Safety Defect and Noncompliance Report Guide for Vehicles  
**PART 573 Defect and Noncompliance Responsibility and Reports**<sup>1</sup>

On 2/24/10, 2007, SUTPHEN [MFR] decided that (a defect which relates to motor vehicle safety)(a noncompliance with Federal Motor Vehicle Safety Standard No. \_\_\_\_\_) exists in the motor vehicles listed below, and is furnishing notification to the National Highway Traffic Safety Administration in accordance with 49 CFR Part 573 **Defect and Noncompliance Responsibility and Reports**.

Make(s): SUTPHEN Model Years Involved: '04-'07 Model(s): SPH

SPH Driveline Campaign

PARTS LIST, AERIAL DRIVE DRIVELINE CORRECTION	
DRAWN BY	J. HAULMAN
DATE	2/09/10
NEXT ASSEMBLY	JNH 3241
FINISH	BY ECN
PER DETAILS	
CHF-2718	
HEIGHT (US)	
SHEET	
1 OF 1

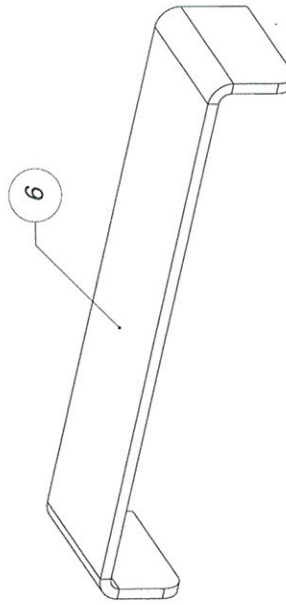
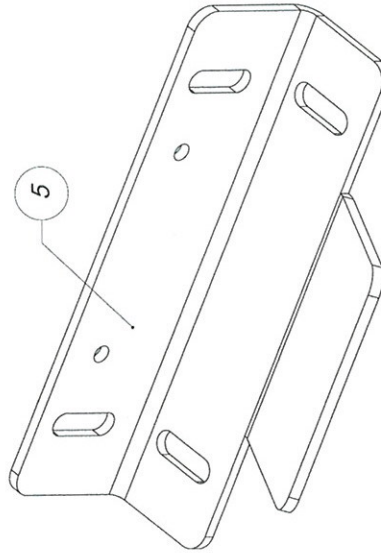
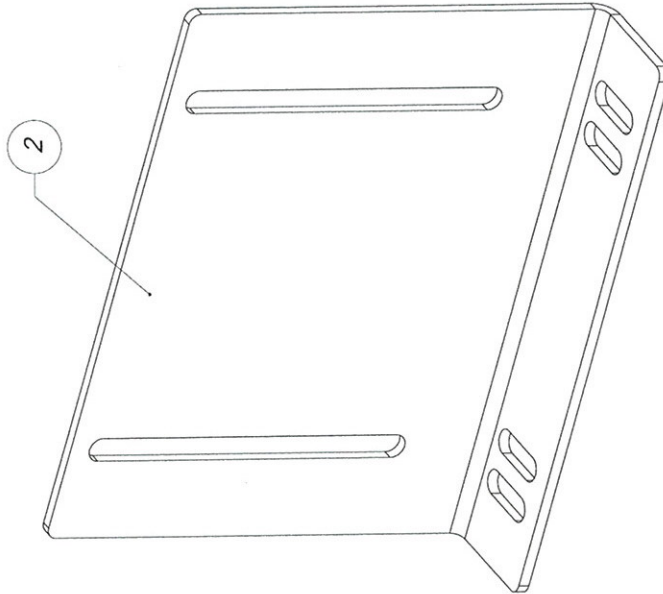
Pre 2007 w/Detroit Diesel 5-60: Modified X-member will Allow Drive line Angles to be within Tolerance. See Attached Description AND CHF-2718 For Details

Pre 2007: Modified X-member is notched (See CHF-2718)

MODIFIED CHF-424 CROSS MEMBER PER CHF-2582 DRAWING

Production was corrected by providing every CHASSIS with A NOTCHED X-member similar to CHF-2718 so ALL Drive line Angles would be in tolerance. Change was implemented JANUARY 15<sup>th</sup> 2010.
